TECHNICAL BULLETIN INDEX
Sorted by Bulletin Number
04/03/86

BULLETIN NO: II:1

PRODUCT: 26-4001/2 Model II

Figure 1

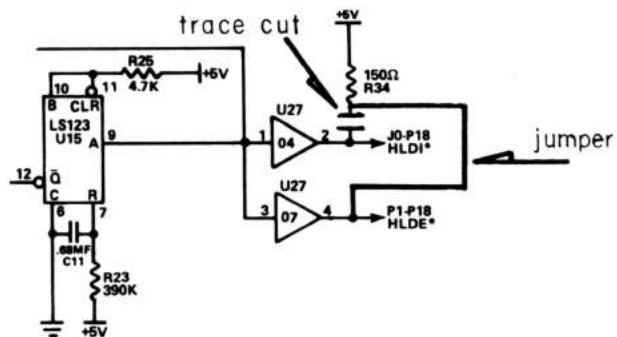
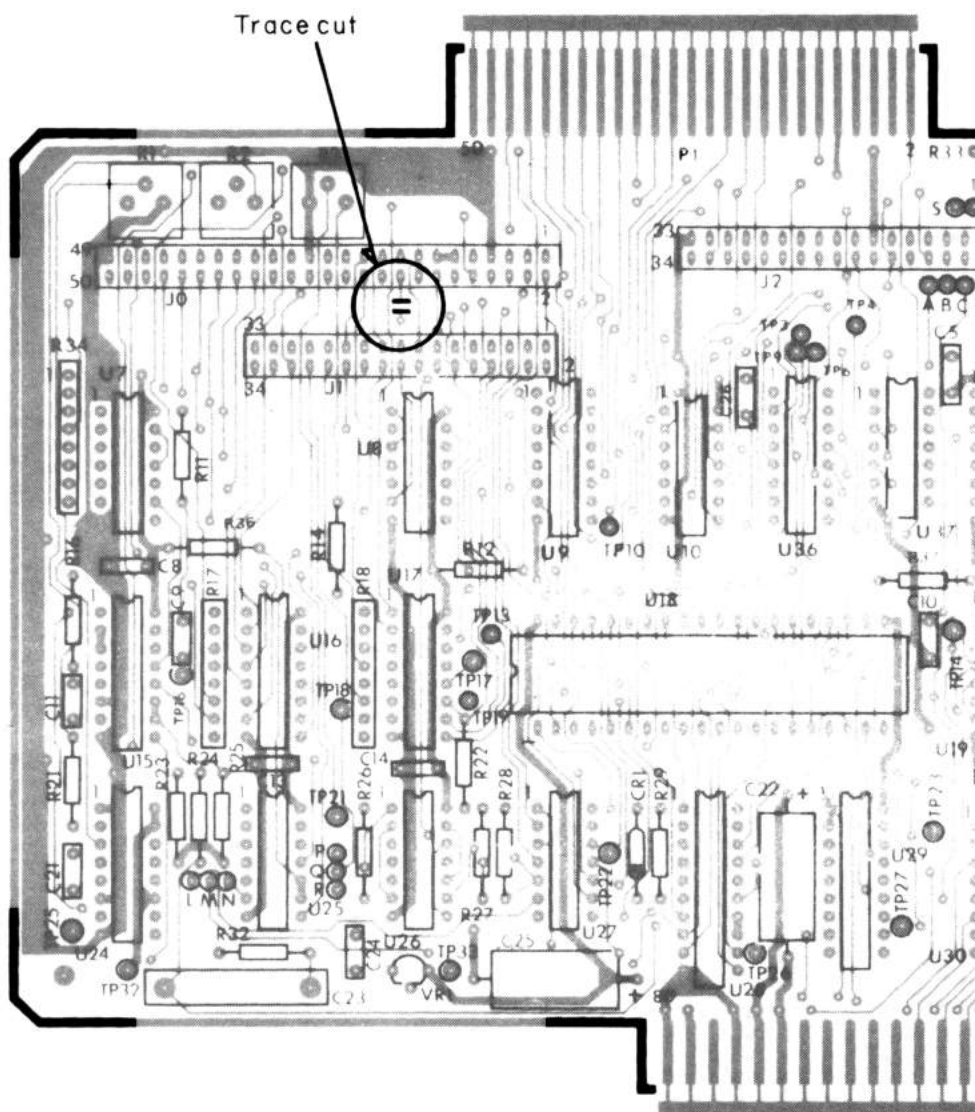
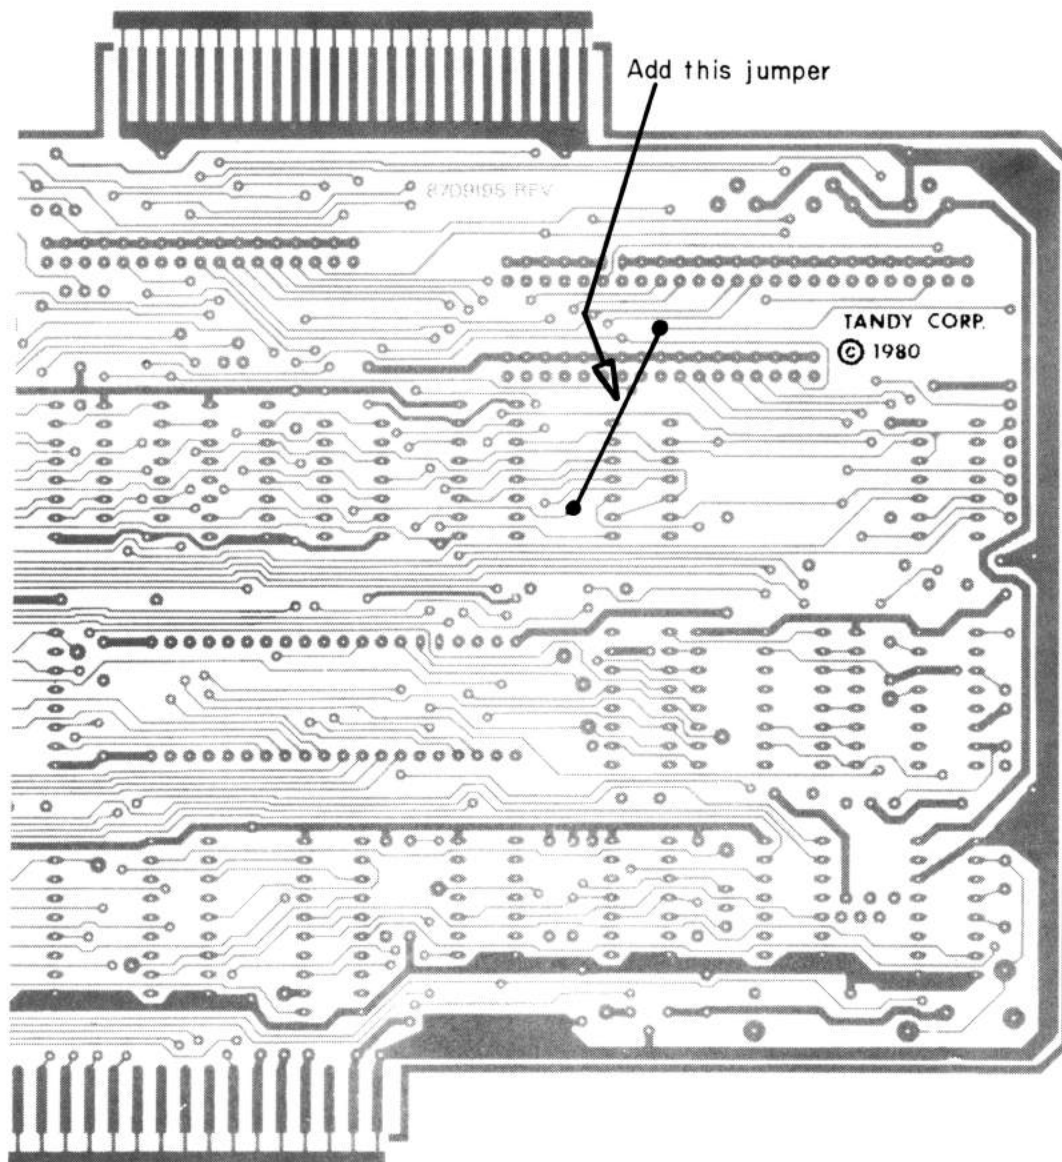
PURPOSE: To correct Head Load termination on FDC board (Late design/Rev Blank).

DISCUSSION: On the redesigned FDC board (Rev Blank) there is a pullup resistor on the Head Load signal for internal drives, but there is none for external drives. With the Model II the internal drive has Head Load termination on the board but the bay does not. With the FDC board (Redesign) this means that the internal drive has double Head Load termination while the external Head Load signal has no pullup. To correct this problem we eliminate the internal Head Load signal on the FDC board and use its pullup for the external Head Load signal (Refer to Figure 1).

1. On the componet side, cut the trace that goes to pin 18 of J0 (the 50 position pin header connector) RIGHT AT the connector so that the feedthru can still be used on the reverse side to go to the external head load signal (Refer to Figure 2).
2. Turn the board over to the solder side and solder a jumper from the feedthru referenced in step 1 (this is the pullup resistor line) to the feedthru between U8 and U9 that is closest to pin 8 and 9 of U8. This feedthru is the Head Load external signal external signal and goes over to U10 on the solder side of the board (Refer to Figure 3).

Figure 1

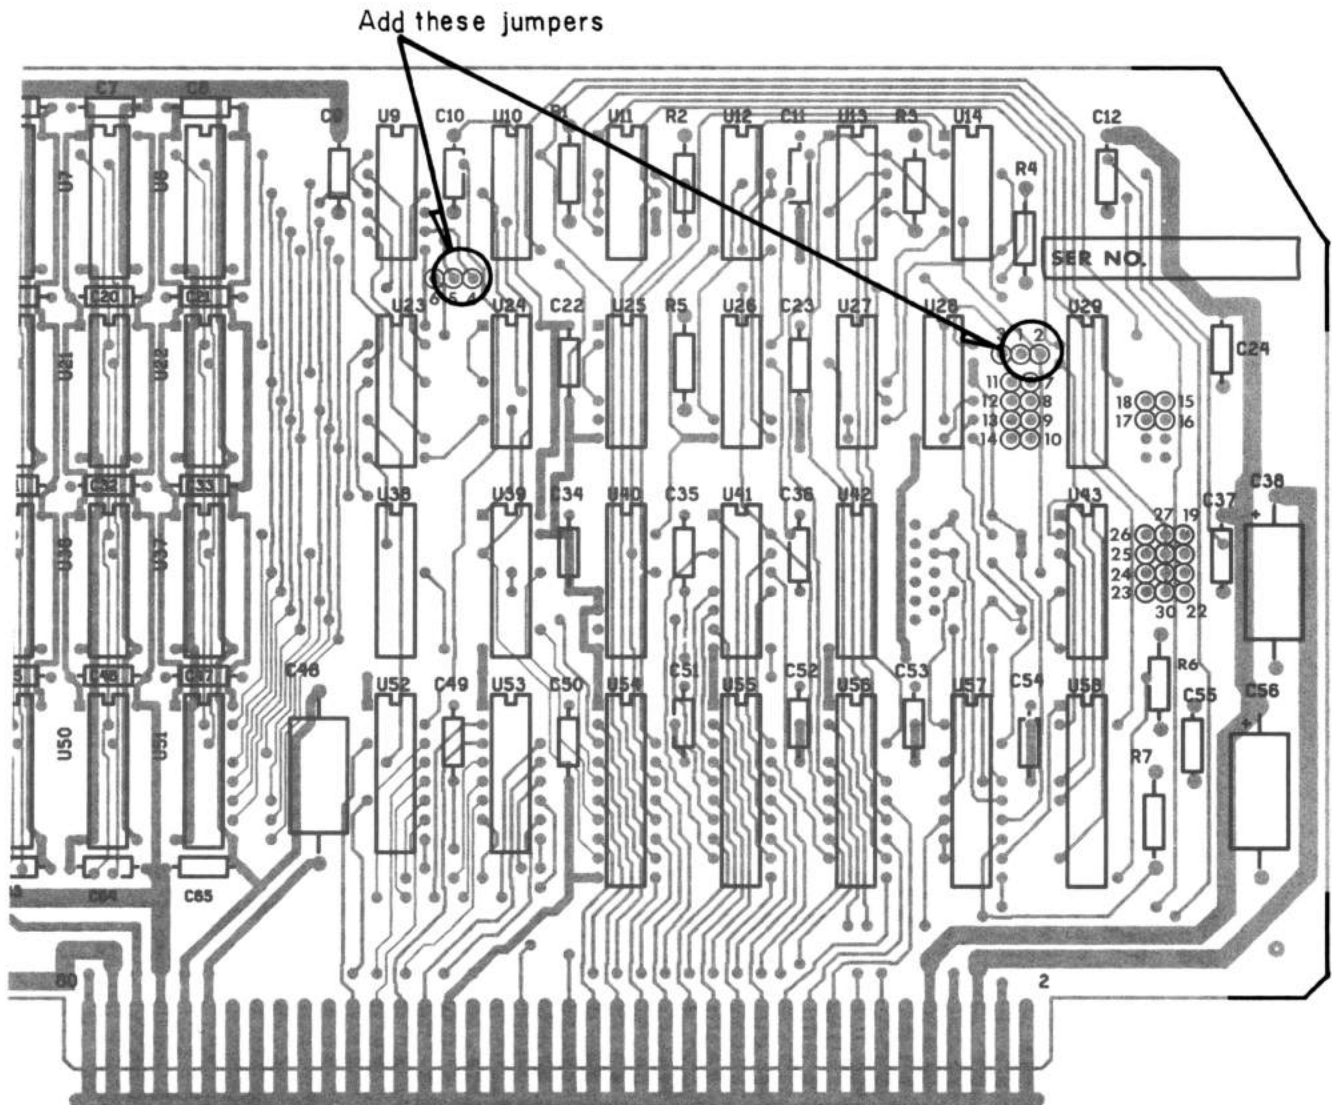
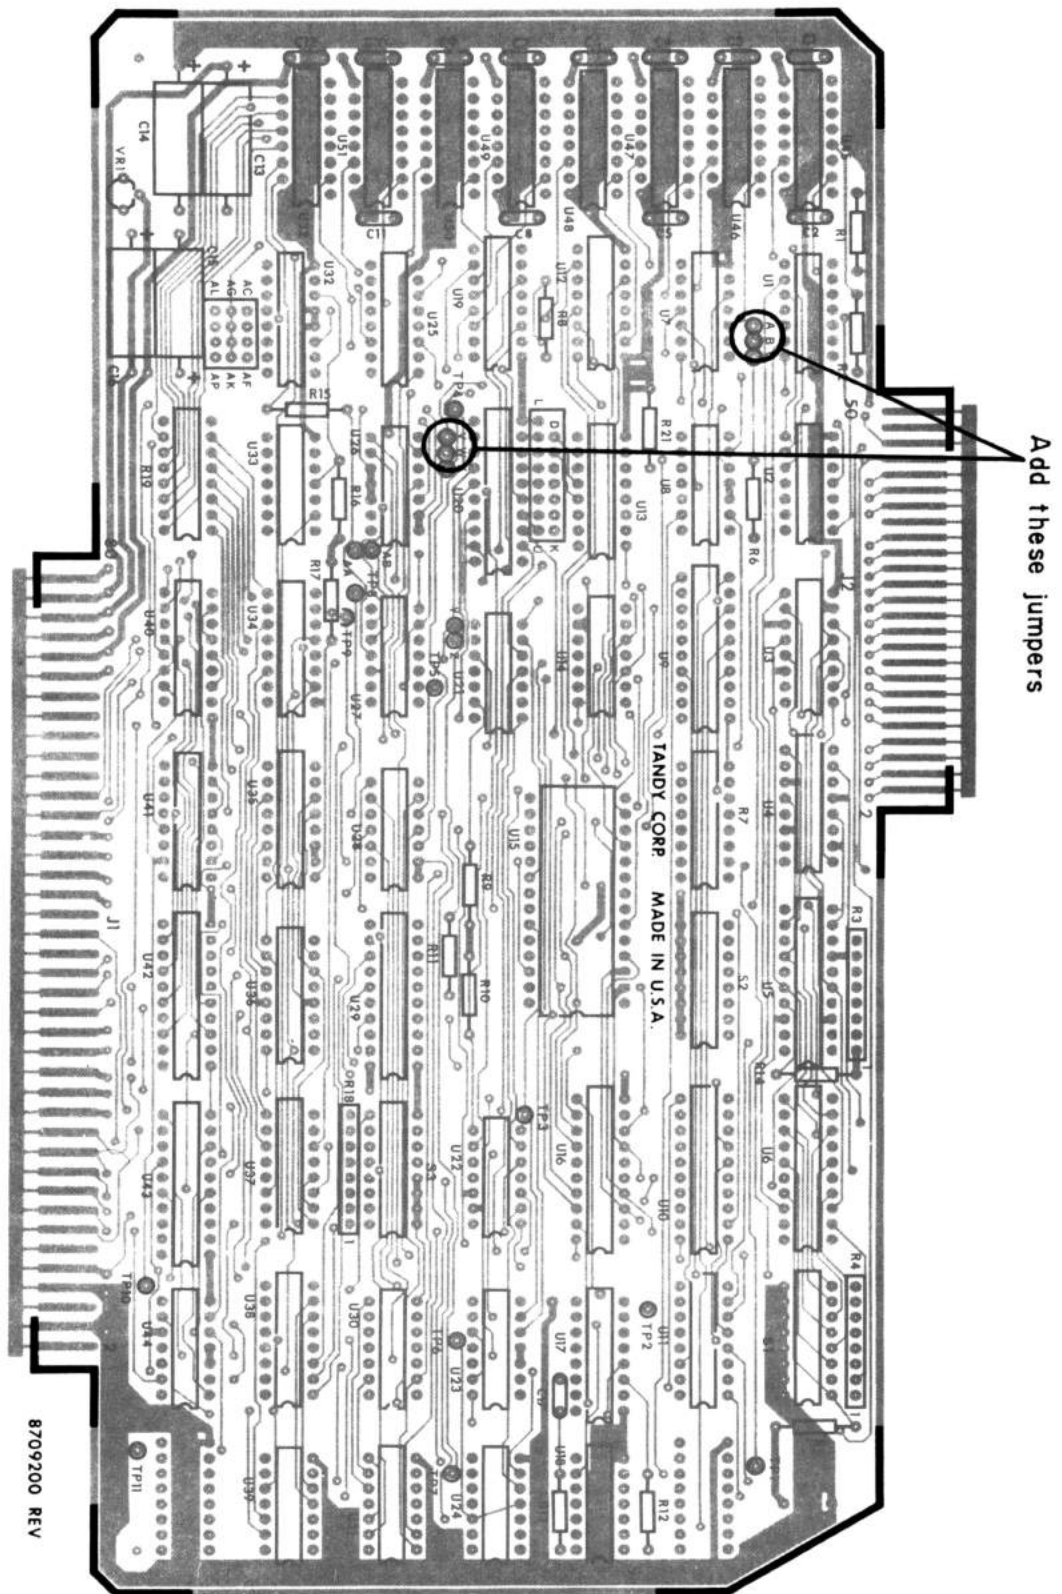
DISCUSSION: Pullups are needed on memory boards for inputs to gates. Intermittent problems can occur without these pullups installed. Some of the Model II memory boards may be missing staking pins for push on connectors and appropriate markings. In this case, use wirewrap to jumper the pads and refer to Figure 1 for pad locations.

PROCEDURE: Check boards for proper jumpering and install jumpers if they are missing. For physical locations of jumpering positions refer to Figure 1 for the memory board and Figure 2 for the Interface board.

Hard Disk Interface:
Jumper A-B and W-V

Model II Memory boards:
Jumper 1-2 and 5-6

Figure 1

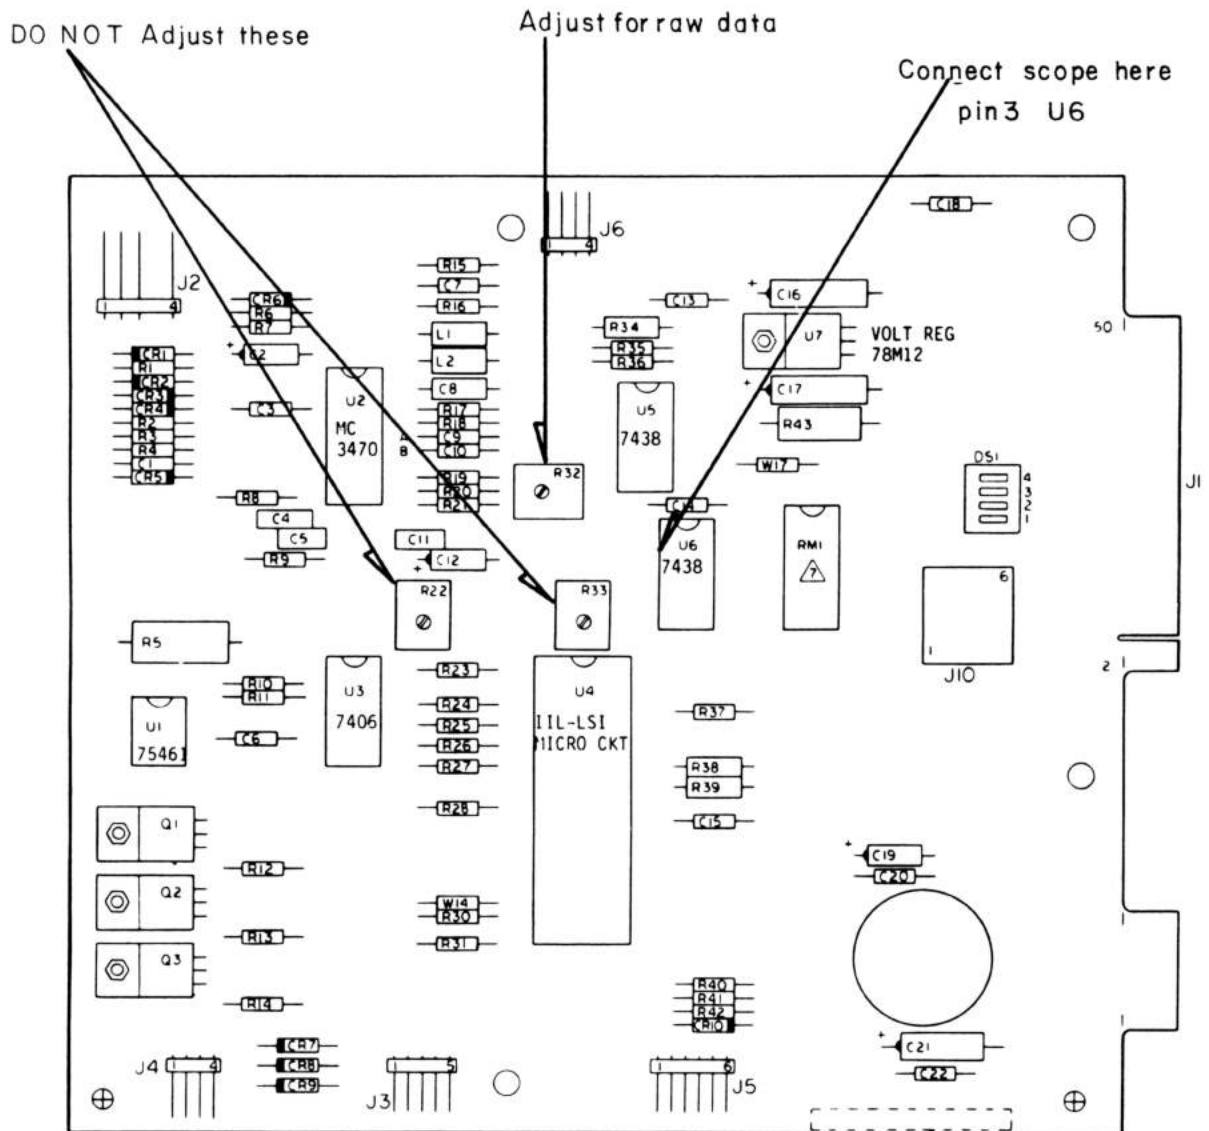
DISCUSSION: The LSI board has three adjustments R22, R23, and R32 (Refer to Figure 1). R22 and R33 are for adjusting the oscillator and write current to the head. These adjustments ARE NOT to be done in the field. The reason for this is because a test jig is needed, excessive time is required to complete the adjustments, and there is a high probability of damaging the head or the LSI chip. Once these adjustments have been done by the factory there is no reason for them to change unless the LSI chip fails. R32 controls the read symmetry (raw data) adjustment and it should be adjusted in the field.

PROCEDURE: Whenever doing drive alignment raw data should be checked with a blank BULK ERASED diskette. Connect scope to U6 pin 3 and proceed to step 8 of the TDC diagnostic. Adjust R32 so that the jitter of the first data pulse is less than 200nsec.

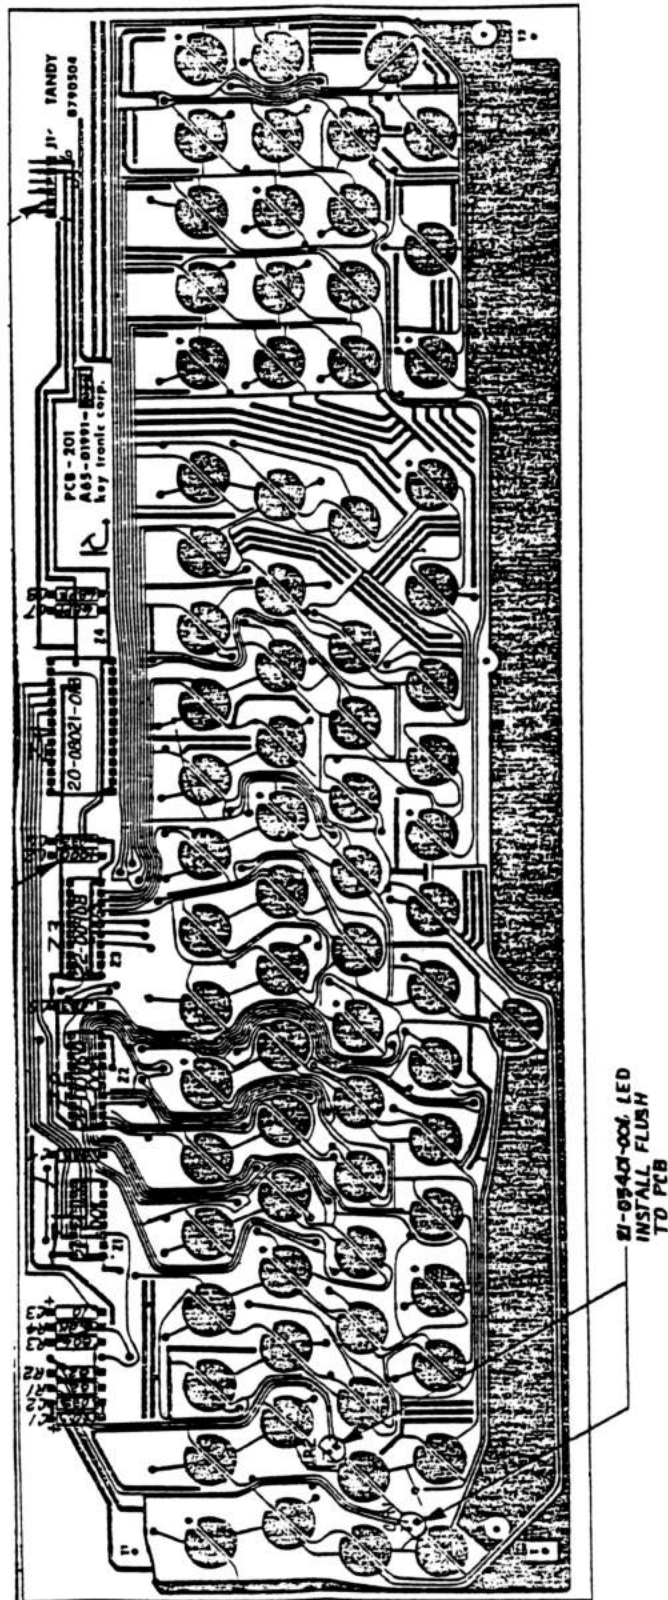
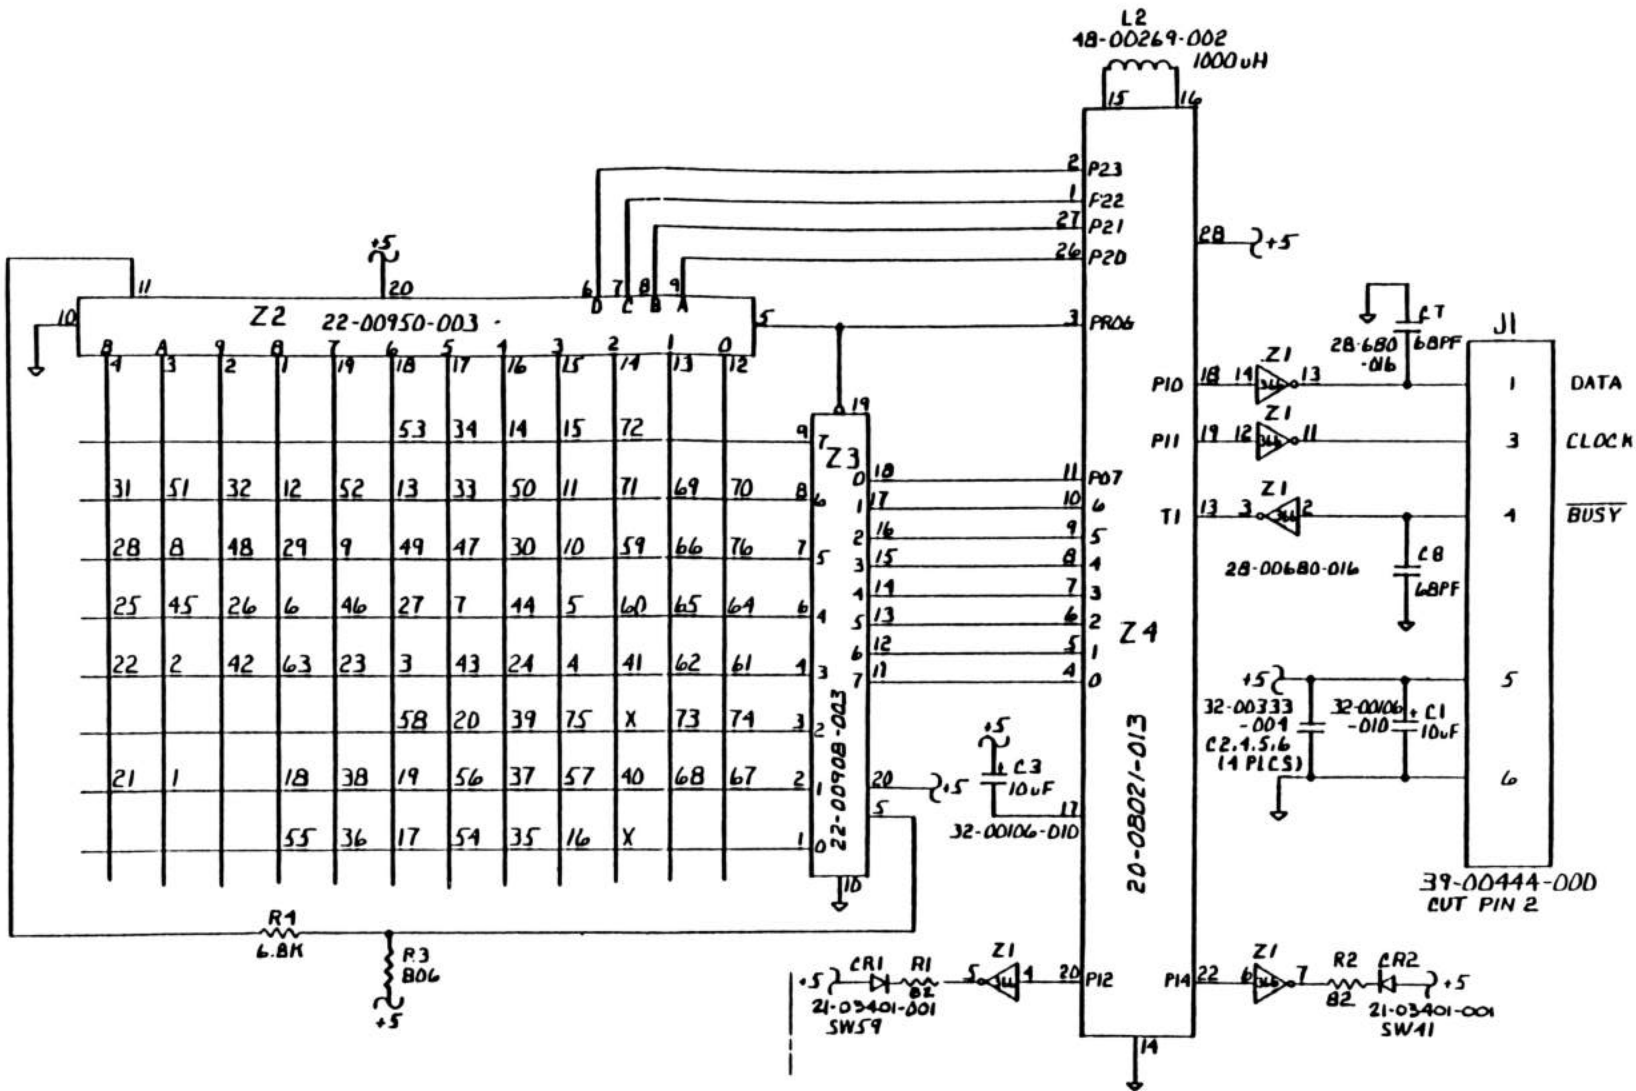
PURPOSE: Correct, and clarify the schematics on the model II/16 Key Tronic keyboards.

DISCUSSION: The Schematics for the Model II/16 keyboards in the Model II Technical Reference Manual are incorrect. Attached is the correct schematic and component location diagram.
